UNITED STATES
DEPARTMENT OF THE INTERIOR
BUREAU OF LAND MANAGEMENT

SUNDRY NOTICES AND REPORTS ON WELLS
Do not use this form for proposals to drill or to re-enter an abandoned well. Use form 3160-3 (APD) for such proposals.

5. Lease Serial No. NMLC029342E
6. If Indian, Allottee or Tribe Name
7. If Unit or CA/Agreement, Name and/or No.
8. Well Name and No. THUNDER ROAD FED 5
9. API Well No. 30-015-32384-00-S1
10. Field and Pool or Exploratory Area LOCO HILLS-PADDOCK
11. County or Parish, State EDDY COUNTY, NM

**Permanent Abandonment of Federal Wells
Conditions of Approval**

** BLM REVISED **

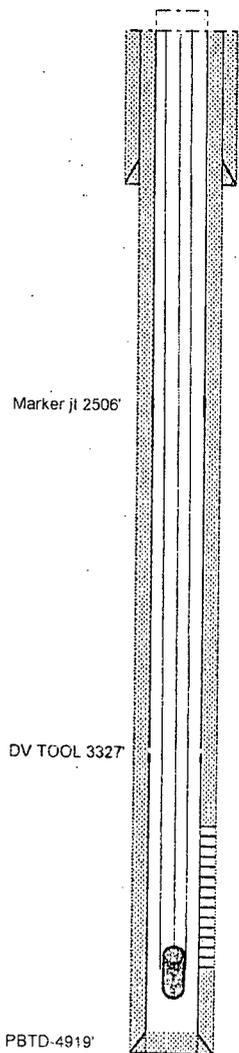
SEE ATTACHED FOR
CONDITIONS OF APPROVAL
RECEIVED

Below ground level dry hole marker required

5. Spot 60 sx cmt @ 576' to surface. (T/Salt & Shoe)

4. Spot 35 sx cmt @ 1200-900'. WOC & Tag (Yates & B/Salt)

3. Spot 25 sx cmt @ 2850-2650'. (San Andres)

2. Spot 25 sx cmt @ 3377-3177'. WOC & Tag (DV Tool)

1. Set 5 1/2" CIBP @ 4288'. Circulate hole w/ MLF. Pressure test csg. Spot 25 sx cmt @ 4288-4088'
